188 Beaumont Street Fast-track

Auckland Council Specialist Memo

Parks Planning

2.0 Technical Specialist Memo – Parks Planning

Figure 2. Snippet of the shading diagram showing the extent of shading produced by proposed development in Summer (6pm) (Source: Architectural Drawings- Part 7)

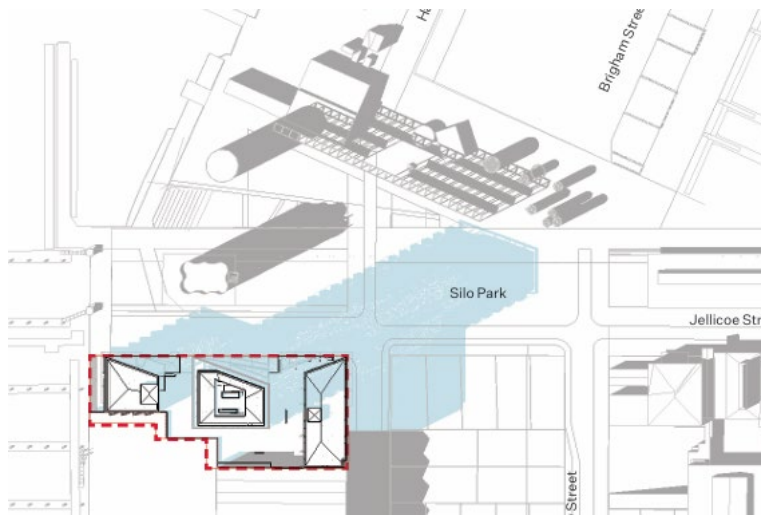
The shading analysis provided by the applicant indicates that shading effects on Silo Park occur primarily during late afternoon and early evening periods, particularly in summer. While these effects are described in the AEE as limited, they coincide with peak periods of use.

Parks and Places specialist, Jacquie Thompson Fell, has reviewed the shading assessment and identifies concern with the reduction in late afternoon and early evening sunlight, noting that these effects are most pronounced in the playground and active recreation areas, which represent sensitive components of the park.

Reduced and inconsistent sunlight across these core activity areas may:

While reviewing the shading diagrams, it is important to acknowledge that the shading effects on Silo Park arise from the overall building configuration, rather than being limited solely to the portion exceeding the permitted height threshold. Consequently, even if the development were reduced to comply with the permitted height limits, it may still result in adverse shading effects on the open space. In light of this, the proposed development, in its overall configuration, would not meet the relevant objectives and policies of the zone and the precinct (H8.3(3), (11), (30), and (38), and I214.2(3)).

Figure 4. Landscape Strategy showing the activities on the ground level of the proposed buildings (Source: Landscape Design Report)

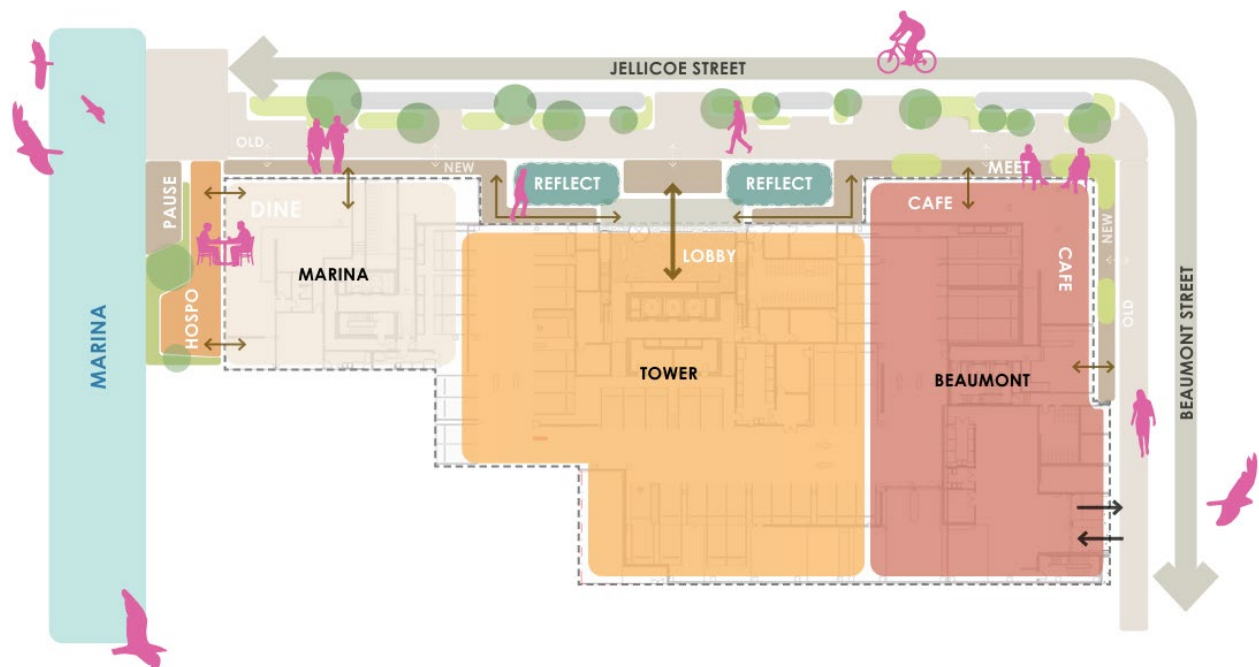
However, while these design responses provide benefits at ground level and reduce perceived dominance from certain viewpoints, they do not directly offset the adverse effects on sunlight access and spatial openness resulting from the increased building height.

However, while such activation provides an amenity benefit at ground level, and the proposed angled setbacks on the higher level may decrease the dominance of the buildings on the street level, the proposal does not directly offset the identified adverse effects arising from the increased building height. These effects are attributable to the height exceedance of the buildings, particularly the middle Tower. While the overall functionality and connectivity of the open space network are not expected to be compromised, the proposal will result in a discernible adverse effect on amenity, particularly in relation to late afternoon sunlight access and user experience within Silo Park.

Figure 5. Snippet from Architectural Drawings-Part 2 showing 7m setback from the water's edge

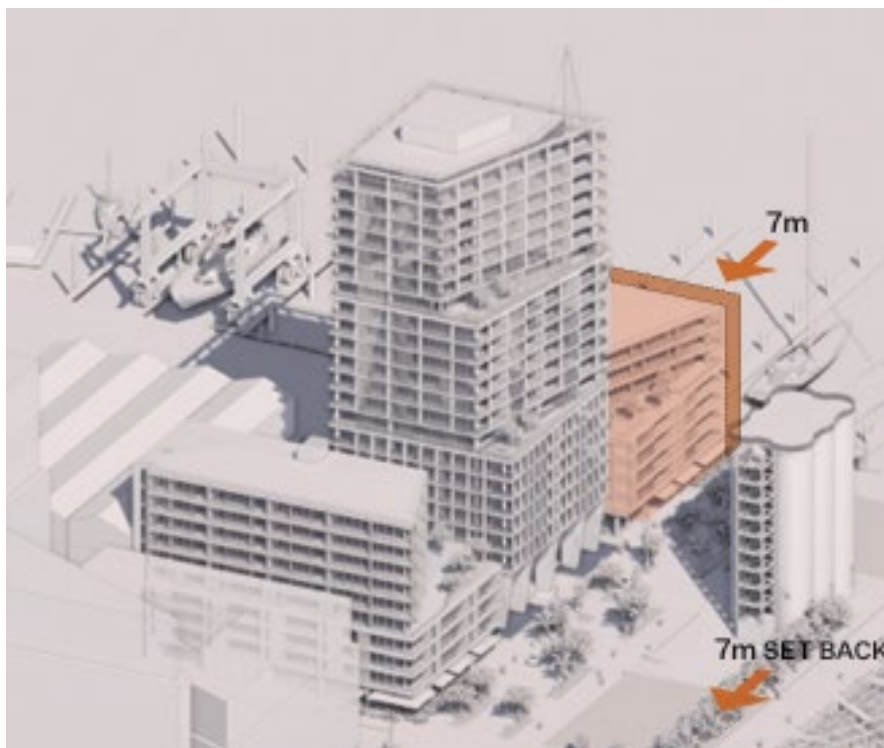
This approach is supported from a park's perspective. However:

- The access arrangement is not clearly secured through the scheme plans or consent framework

Accordingly, it is recommended that:

- A condition of consent be imposed requiring formalisation of this access
- A condition will also be required for clarity of responsibilities and ongoing public access.
